**COMMITTEE OF ADJUSTMENT
MINUTES**

Application: A-37/16
Owner: Amanda Bouck & Marty Gordon
Agent: Aimee Chisholm
Location: 48 Marlborough Drive
In Attendance: Aimee Chisholm
Marty Gordon

Attachments
48 Marlborough Drive – Red Line Drawing

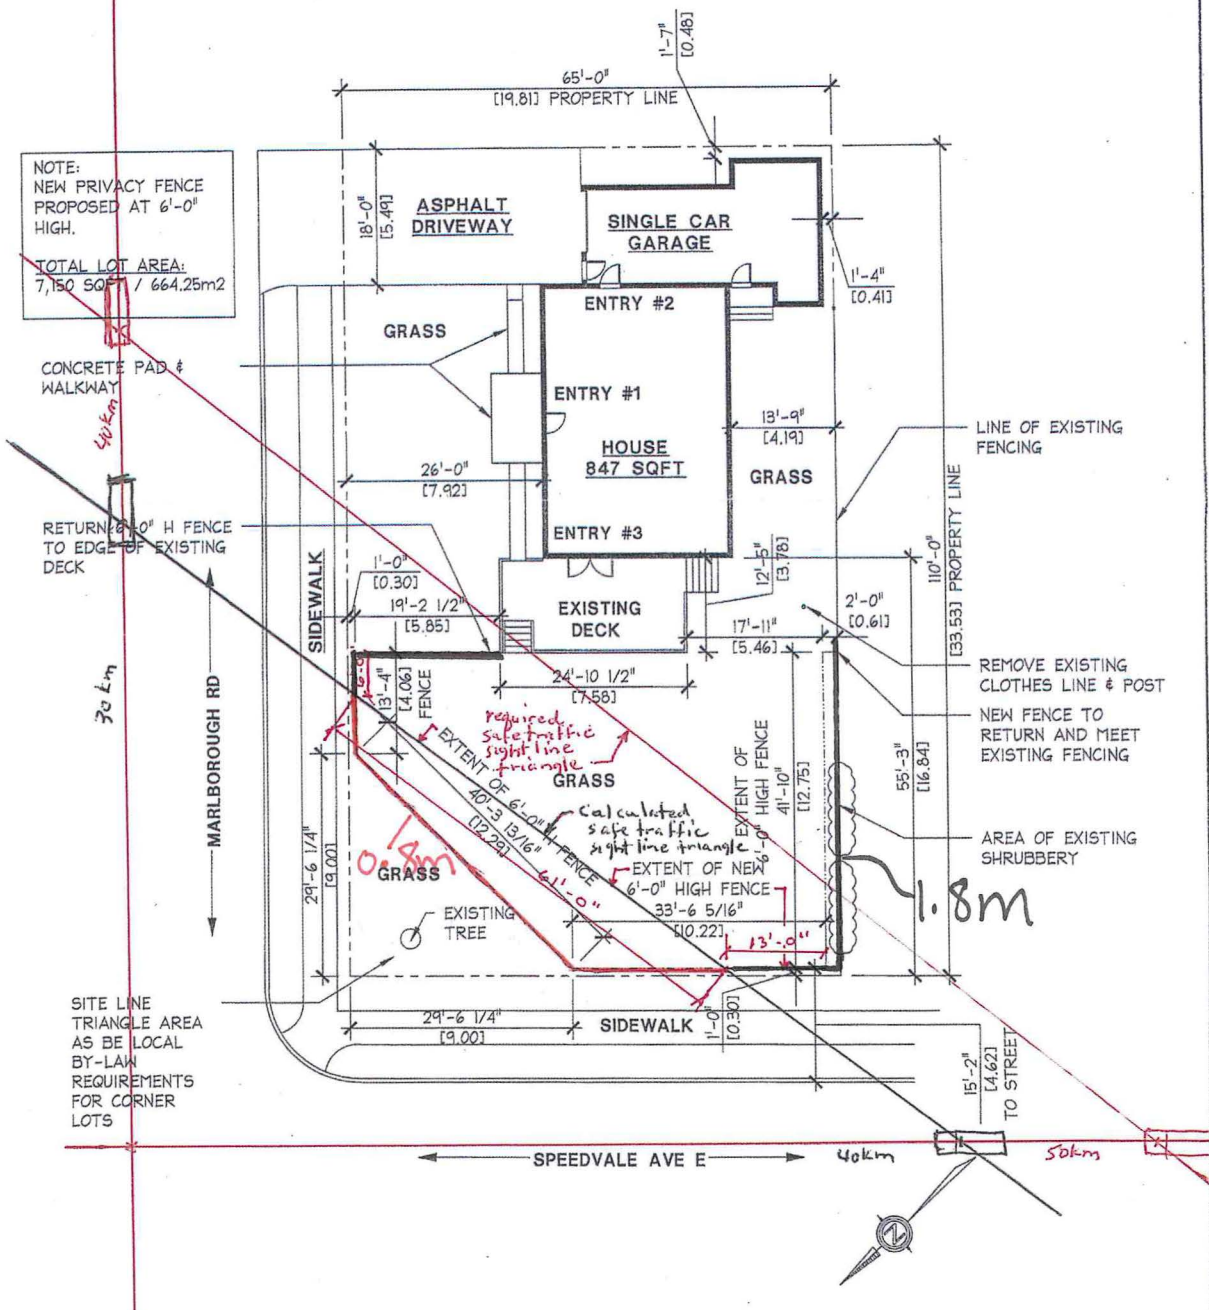
Ms. A. Chisholm asked why the 9 metre by 9 metre sight line included in the By-law was not sufficient enough for staff to support this application as proposed. Furthermore, she inquired as to why Engineering staff would propose a sight line triangle that is larger and more stringent than the one included in the By-law.

Planner L. Sulatycki indicated that staff would only support the location of the fence as described in the conditions offered by Engineering and not in the location proposed by staff. Furthermore, she indicated that Engineering staff use safe sight line triangles recommended by the Transportation Association of Canada when reviewing variance applications in addition to those found in the By-law.

In response to a question from Chair B. Birdsell, Planner L. Sulatycki explained that front yard fences in residential zones must be no taller than 0.8 metres in height while exterior side yard fences shall not exceed 2.5 metres in height from the mid-point of the main building to the rear property line and must be no taller than 0.8 metres in the remaining exterior side yard.

Planner L. Sulatycki explained that the Transportation Association of Canada recommended sight line triangle isn't included in the current Zoning By-law but is used by Engineering staff on a case by case basis to ensure the safety of drivers and pedestrians and to minimize municipal liability if a variance is permitted.

Member M. Bosch indicated that the fence, as proposed by the applicant, would significantly reduce visibility at the corner of Speedvale Avenue and Marlborough Drive. Furthermore, he suggested that the application needed to be judged on its own merits.

In response to a question from Member L. Janis, Ms. A Chisholm suggested that the height of the fence could be reduced to 0.8 metres along the angled portion.

Member M. Bosch suggested that wrought iron fences do not provide clear sight lines and that the purpose of a sight line triangle is to provide sight lines that are entirely unobstructed.

Mr. M. Gordon suggested another option would be to maintain the 1.8 metre fence height outside of the sight line triangle put forward by engineering.

Chair B. Birdsell clarified that the applicant was proposing to build a 0.8 metre high fence within Engineering's proposed sight line triangle and a 1.8 metre high fence outside of it.

1. That the owner shall install the proposed 1.80-metre (5.90 feet) high fence along the applicant's proposed fence line, except for inside the calculated safe traffic sight line triangle as shown on the attached red line drawing provided by Engineering staff and amended at the hearing.
2. That the fence is constructed within 30 days of the Committee's final decision and in the location shown on the attached site plan.
3. That the fence is constructed in general accordance with the fence detail submitted.
